Revision B
Sept 11, 2015

This revision replaces all previous versions.
Changed application box to reflect SAP notifications

HOT GAS BYPASS IMPROVEMENT, SMALL AC [H3 VIP] Prevost vehicles

Following **WB13-04**, update the hot gas pickup tube circuit for an improved version with a better resistance to vibrations.

Figure 2 : Remove WB13-04 bypass if installed on vehicle.

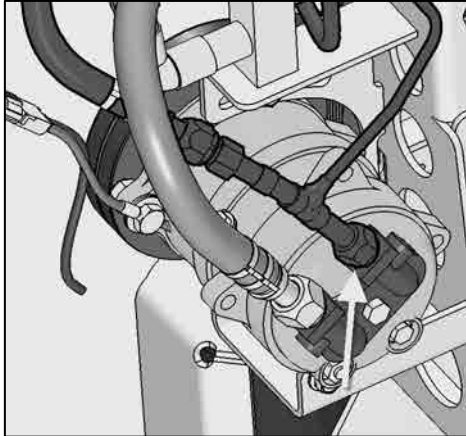
3. Disconnect compressor side only of high pressure hose (Fig.3) and remove WB13-04 bypass piping, if installed (Fig. 2).

Figure 3

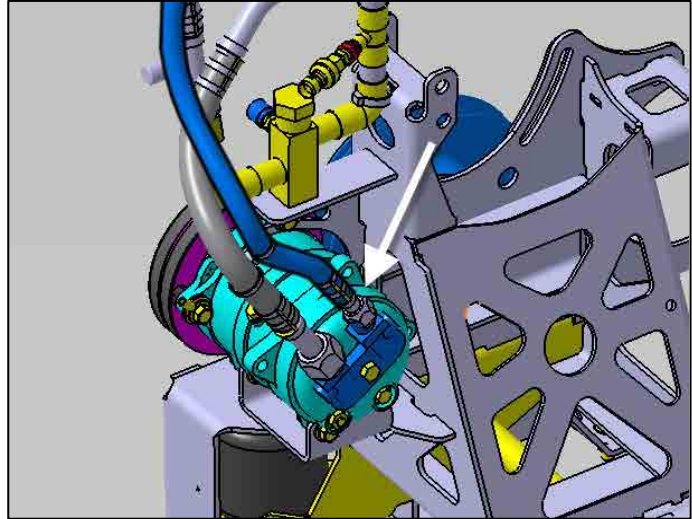
The high pressure hose will be used downstream from the bypass kit.

If hose is damaged, order #450727.

Figure 5

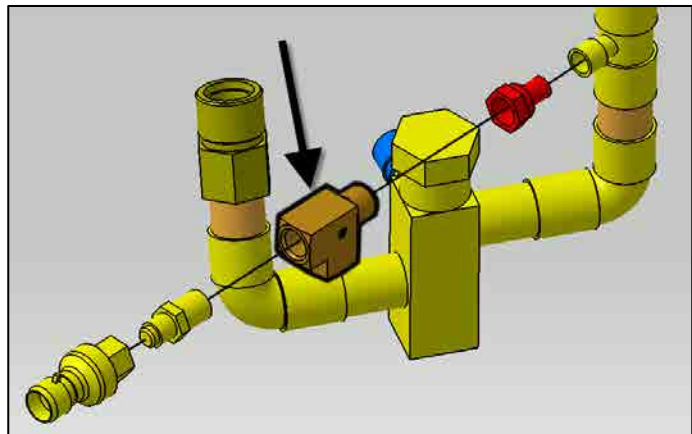
- Add tee 501338 at arrow location between existing components.
- Apply Loctite 567 thread sealant #680098 on all fitting connections

Figure 6

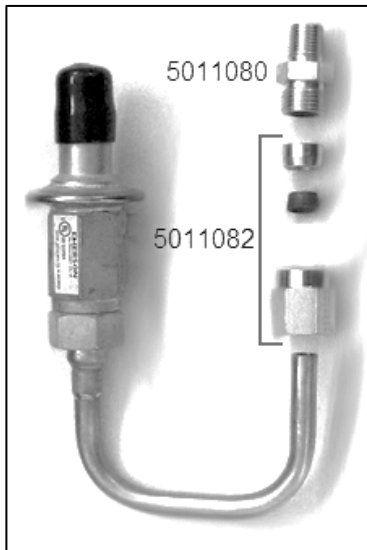
- Install #5011082 compression fitting on the bare end of the bypass tube welded assembly. (Fig 6) Make sure the end is extra clean and free of burrs. In doubt, use a fine "Scotch Brite" type scouring pad.
- Install #5011080 ORS adapter between the compression fitting and the female Tee. (Fig. 6)

Figure 8 : Hose installation

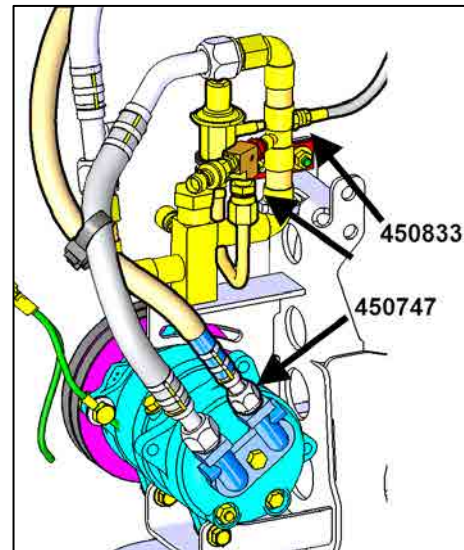
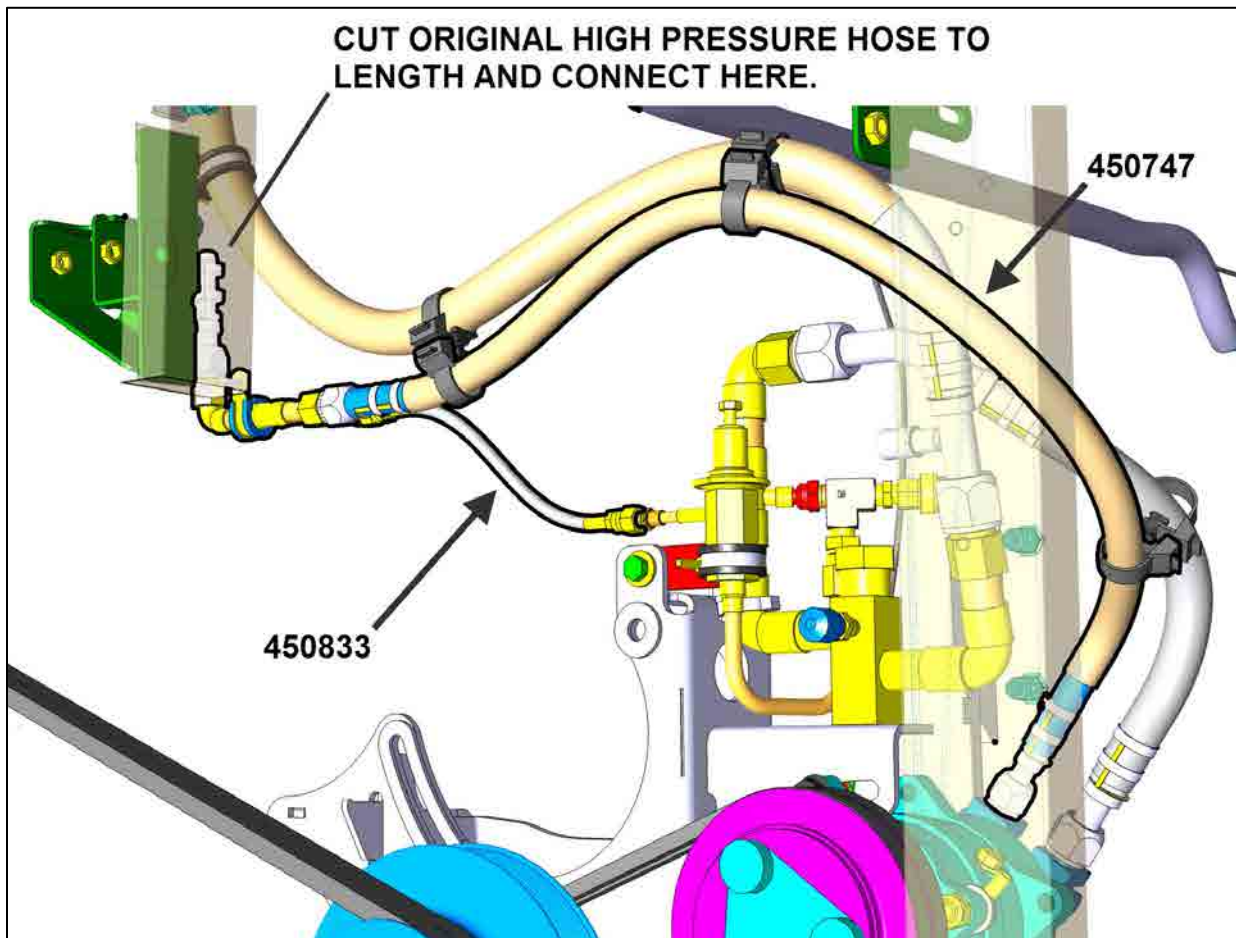
9. Connect #8 size hose #450747 to compressor high pressure outlet. (Fig. 7 & 8).
Connect #4 size hose #450833 to bypass valve. (Fig.7 & 8)

Figure 9 : Hot gas pickup tube

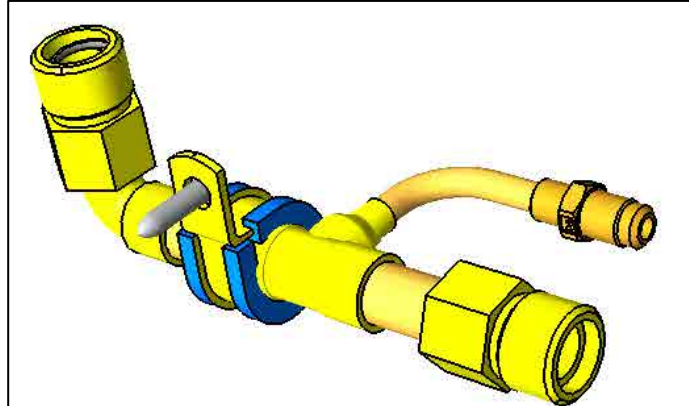
10. Connect hoses #450747 and #4 size hose #450833 to hot gas pickup tube (Fig. 8, 9 & 10).

Figure 10

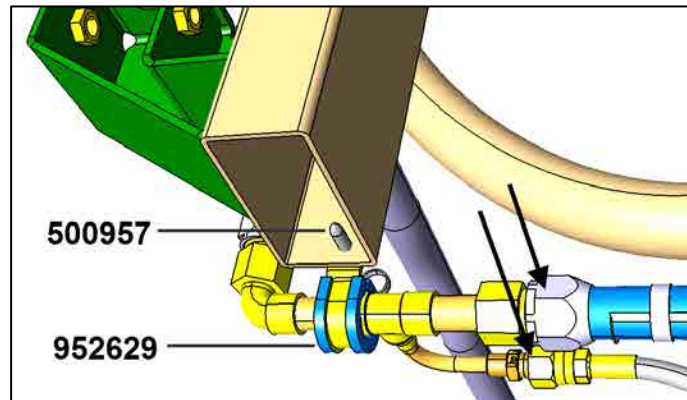
11. Install hot gas pickup tube on vertical tube next to engine door springs with clamp #952629 and binding screw 500957. (Fig. 10)

Figure 11

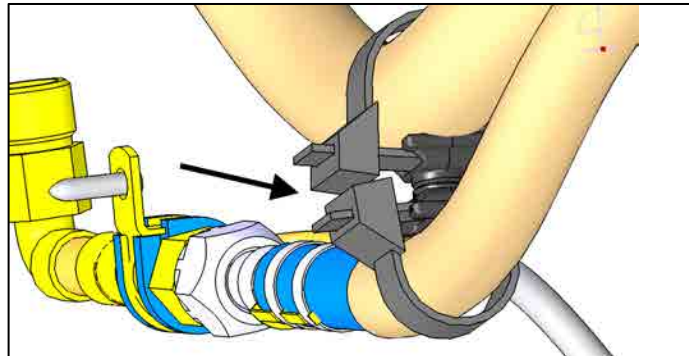
12. Support hose #450747 at required locations to prevent abrasion with #504751 dual swivel cable tie base. (Fig. 8 & 11)

13. Using a suitable cutter, cut the original high pressure hose (From step 3) to required length to install hose fitting. (Fig. 11)

Figure 12 : Eaton E-Z Clip System™

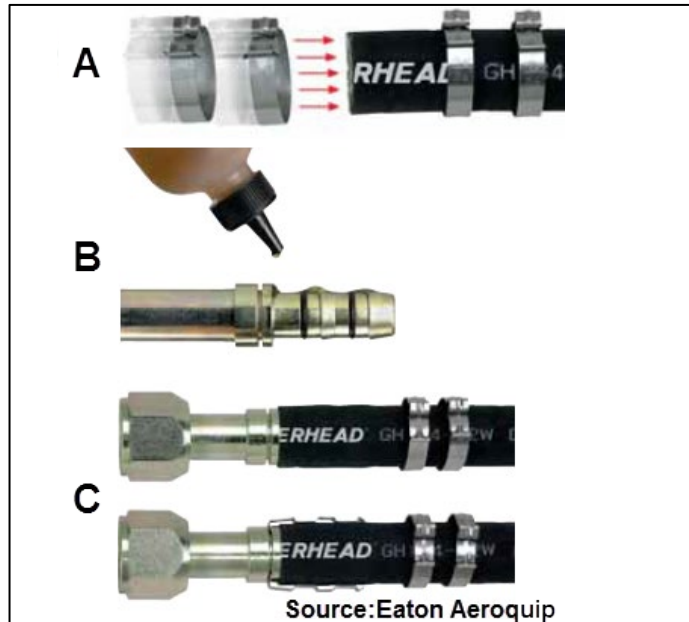
14. (Fig. 12, **A**) Slip the two clamp rings #504761 on the hose.
15. (Fig. 12, **B**) Oil the nipple on fitting #5011319 with oil compatible with A/C systems. This must be done to ease the insertion of the nipple in the hose.
16. Insert nipple in hose up to fitting shoulder. Wipe excess oil.
17. Slip O-ring #507343 in fitting cavity.
18. (Fig. 12, **C**) Snap cage # 504765 in fitting groove over hose. The cage must be able to rotate in the groove.
19. Slip clamp rings over the cage arms and into the channels on each arm. (Fig. 13) Rotate the clamp rings to have the clasp neatly placed between cage arms, not over.
20. (Fig. 13) Close the clips with crimping pliers #504767. The pliers should be placed squarely on the camp ring connection points and remain square during the closing of the clamp.

For easiest assembly, the clasp should be closed *between the cage arms*. (Fig. 13)

If the pliers are not kept square during closing of the clip, the clasp may have an offset. Use the pliers to correct the clasp alignment. (Fig. 13)

Figure 14

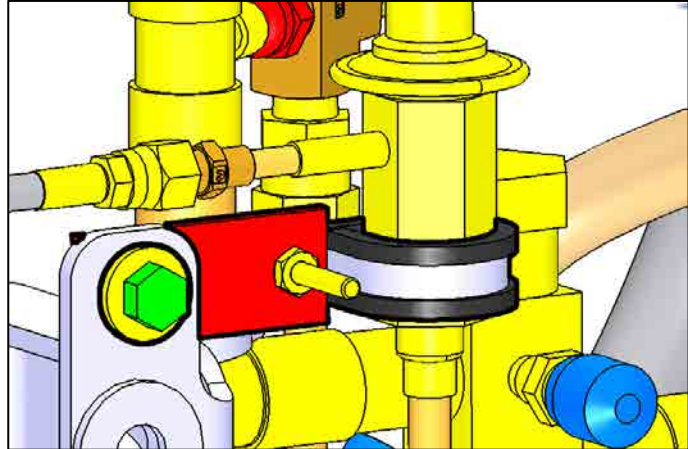
21. Support by-pass valve to alternator bracket with support #060840, P-Clamp #952637 and provided hardware.

Assemble clamp and support as shown.
